Report on Consultation (Route Options)
Loch Fearna Pumped Storage Hydro
Connection
September 2025

REF: LT000506-507

Project: LT000506-507 - Fearn PSH Grid Connection: Report on Consultation (Route Stage)

Title: Figure 1 - Route Options

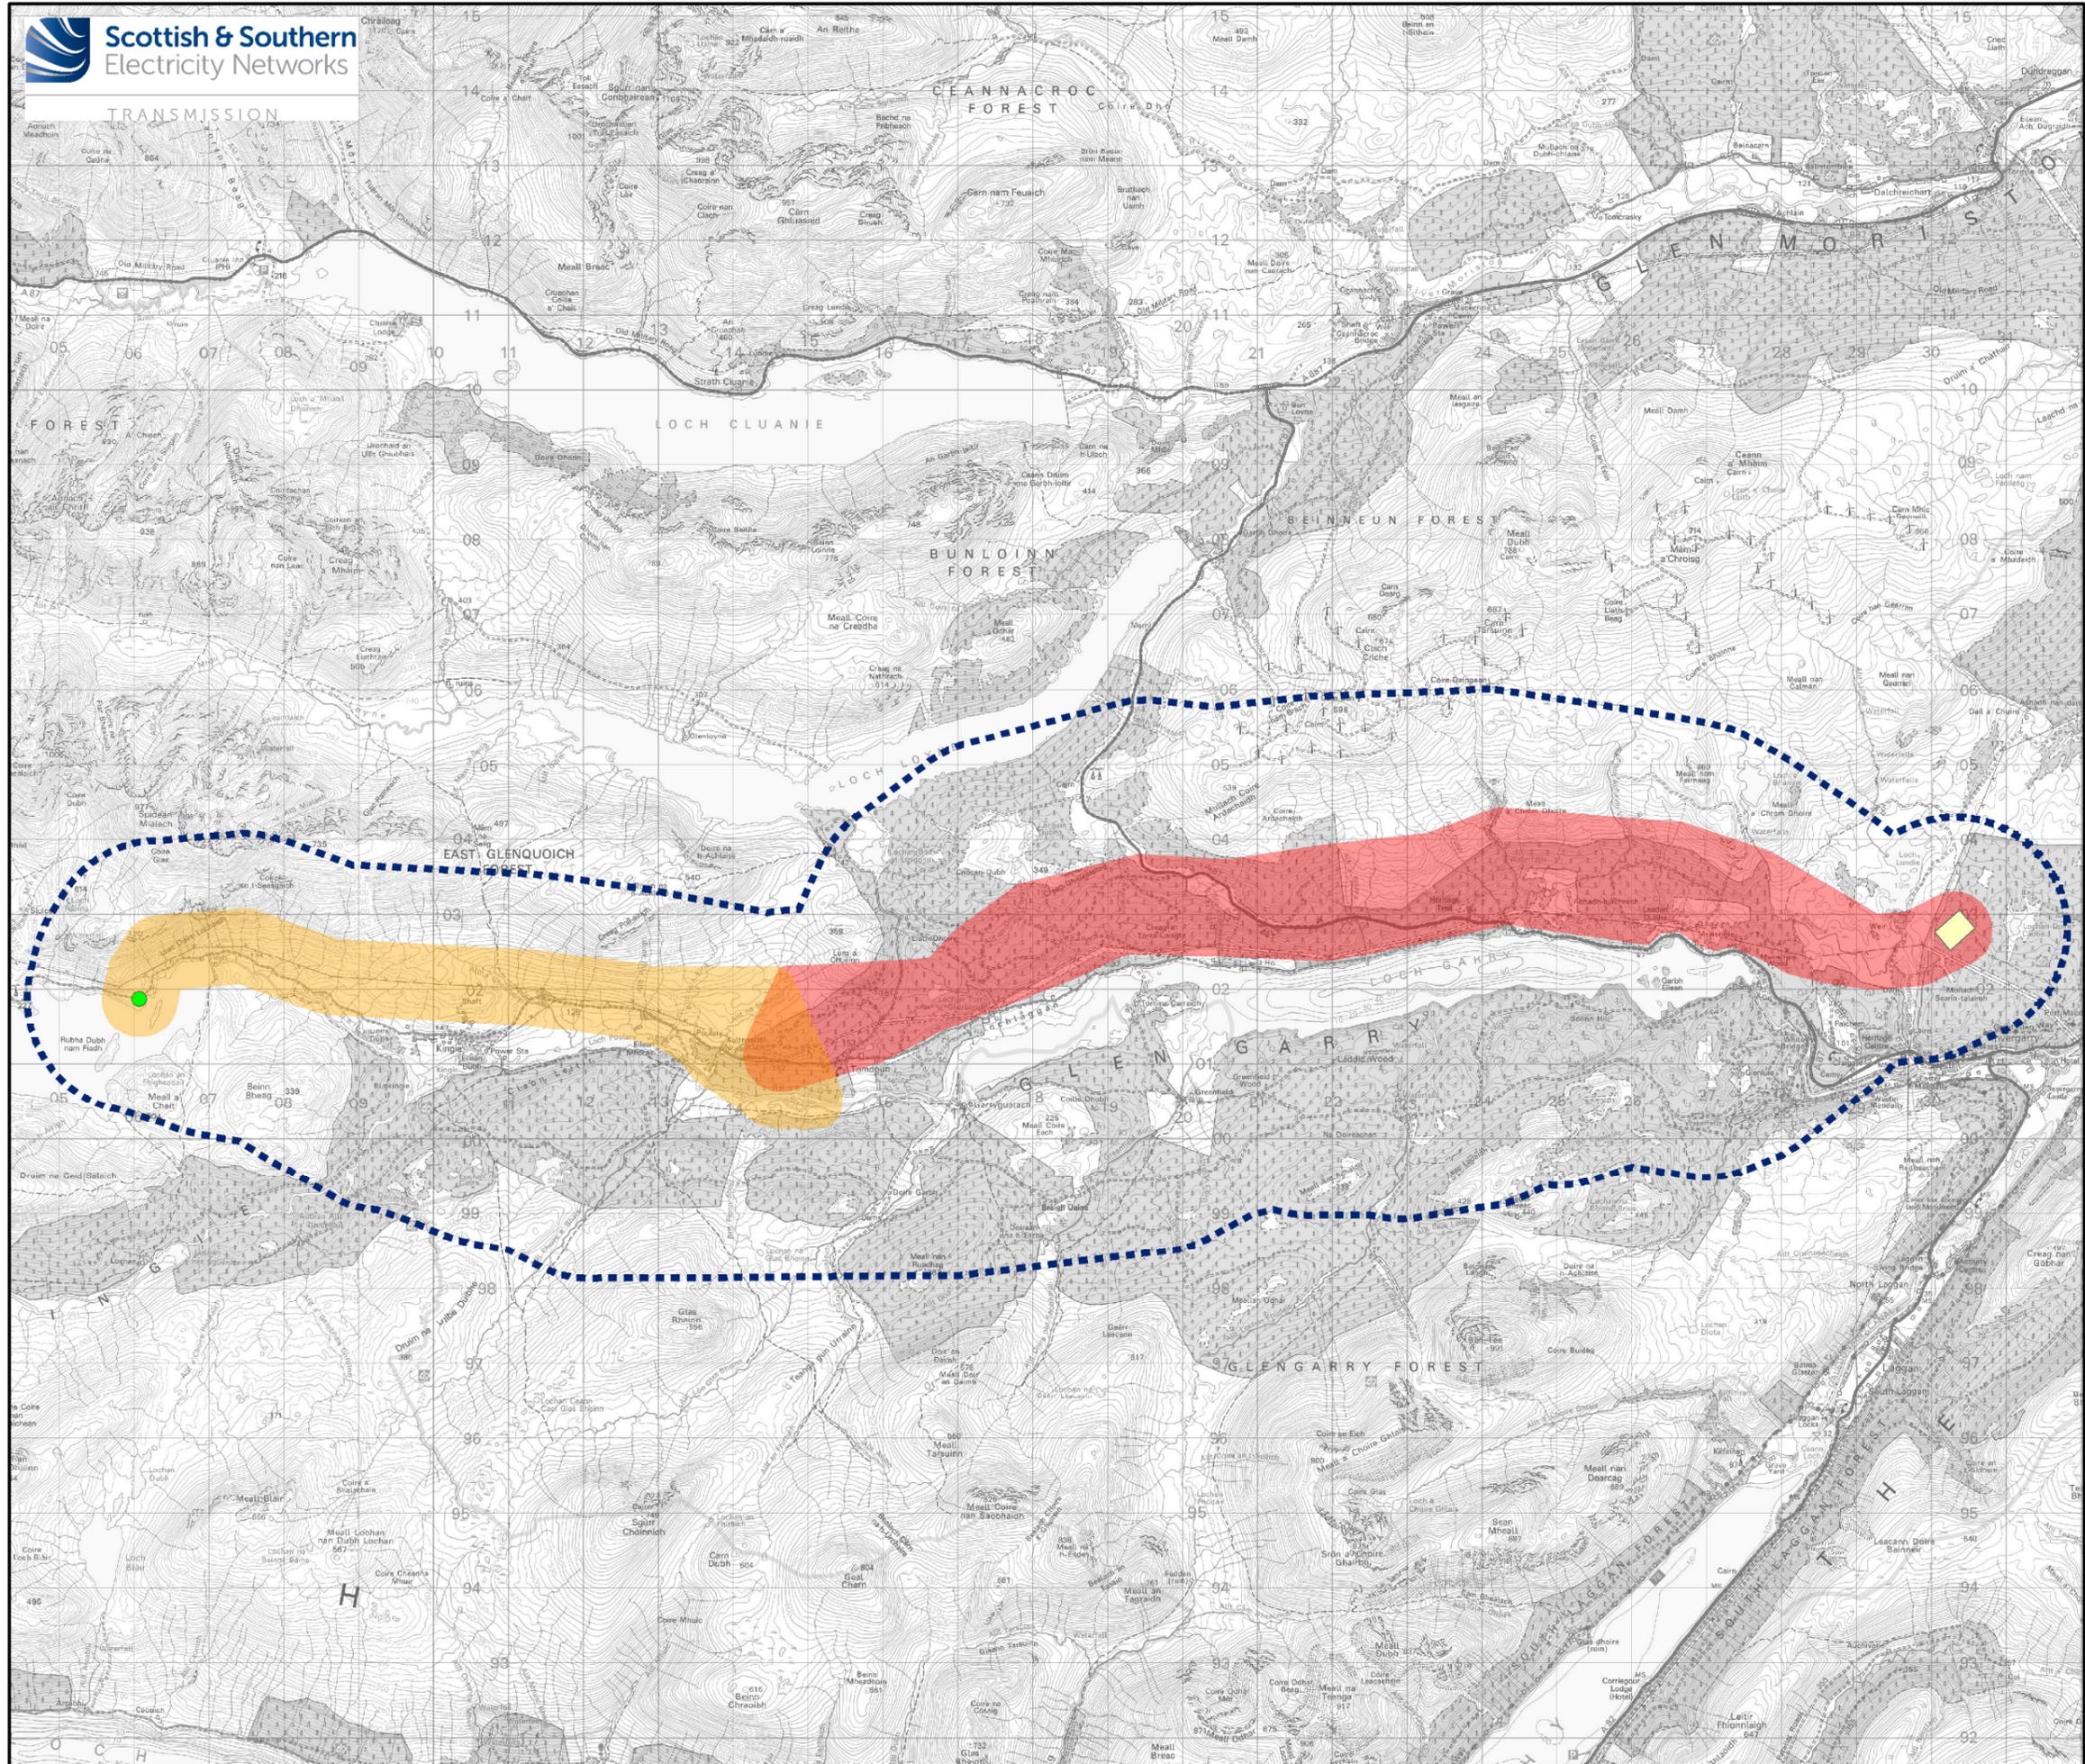
NatureScot note that Route Option 2b may pose a lower collision risk than Route Options 2a and 2c, due to its location south of Loch Garry and the potential to underground Route Option 1b at the Loch Cuaich crossing. However, without full survey data, they cannot determine which option minimises collision risk to SPA birds. Their initial view is that a route south of Loch Garry may be preferable, and they advise obtaining desk study information from the RSPB, particularly regarding additional constraints associated with Route Option 2c.	As set out in the Consultation Document (May, 2025) ³ , SSEN Transmission acknowledge that a route south of Loch Garry may pose a lower collision risk, particularly if undergrounding at Loch Cuaich is feasible. However, in accordance with SSEN's routeing guidance, a balance needs to be struck to achieve the best solution, taking into account all environmental, technical and economic considerations. In this case, the Consultation Document (May, 2025) ³ identified how an OHL route to the south of Loch Garry would pass through extensive and continuous areas of ancient woodland, Caledonian Pinewood and native woodland, requiring significant felling. The associated habitat loss, fragmentation, and disturbance would impact a variety of protected species, including red squirrel, pine marten, and wildcat. There would also be potential for cumulative effects (including cumulative landscape and visual effects)

<p>RSPB queried the basis for the statement in Section 6.2.3 of the Consultation Document that Route Option 1a "avoids key commuting flight paths between the lochs." They note that they are not clear on how these flight paths were identified.</p> <p>Furthermore, RSPB note that they would not agree with the assumption in Section 6.2.6 of the Consultation Document that Common Scoters are likely to take the shortest, lowest flight path between Loch Garry and Loch Loyne. They note that little is known about Common Scoter movements and argue that flight paths may be influenced by factors such as feeding areas, topography, weather, wind farms, and artificial lighting. They also reference previous observations of the species flying and breeding at high altitudes.</p>	<p>On the assumption that commuting flights between Loch Garry and Loch Loyne occur, then these flights are more likely to be the most direct flight line between lochs where the intervening topography is lowest. This is based on the understanding that common scoter will follow the lowest topography and avoid flying over high ground to minimise energetic cost and effort, and, to minimise the risk of predation. A theoretical flight corridor was provided in Appendix V2-5.5: Figure 5.5.3 of the Skye Reinforcement Project EIA Report (September 2022) that illustrated a route utilising a natural saddle in the landscape.</p> <p>This theoretical flight corridor has previously been accepted by both NatureScot and RSPB in their consultation responses to the Skye Reinforcement Project.</p> <p>Such routes necessarily involve flying over currently unmarked earth wires associated with the existing 132 kV steel lattice tower OHL, the existing replacement 132 kV OHL supported on wood poles, and the existing unmarked 33 kV distribution lines. There are no records of collision mortality associated with the existing OHLs within this area.</p>

Stakeholder	Summary of Feedback	Response / Action by SSEN Transmission
	<p>RSPB express serious concern about both the individual and cumulative effects of Route Options 1a and 2a when considered alongside existing overhead lines and the Skye Reinforcement Project. They highlight the potential for adverse impacts on SPA species, particularly Common Scoters and Black-throated Divers, due to the height of the proposed 60 m towers. These concerns are heightened by evidence that these species often fly at low altitudes, including during nocturnal movements between breeding lochs, which may place them at greater risk of collision with the proposed infrastructure.</p>	<p>The potential for collision risk of an OHL within Route Options 1a and 2a is noted within the Consultation Document (May, 2025)³ and is well understood by SSEN Transmission and their technical advisers given the recent work undertaken as part of the consented Skye Reinforcement Project. More detailed assessment of collision risk, including the potential for cumulative impacts, will continue to be explored as the project progresses to alignment selection stage.</p> <p>SSEN Transmission are also aware that in 2023, NatureScot commissioned an Expert Opinion Review to aid their understanding of common scoter behaviour related to the West Inverness-shire Lochs SPA. From what is publicly available in NatureScot's April 2023 updated response to the Bunloinn Wind Farm application (ECU00003304), it was concluded that there is no evidence for scoters flying between the main SPA breeding lochs, although foraging flights between the main lochs and their associated lochans are likely to occur.¹² It is stated that there is also no evidence that breeding females undertake flights between the main lochs at night.¹²</p>
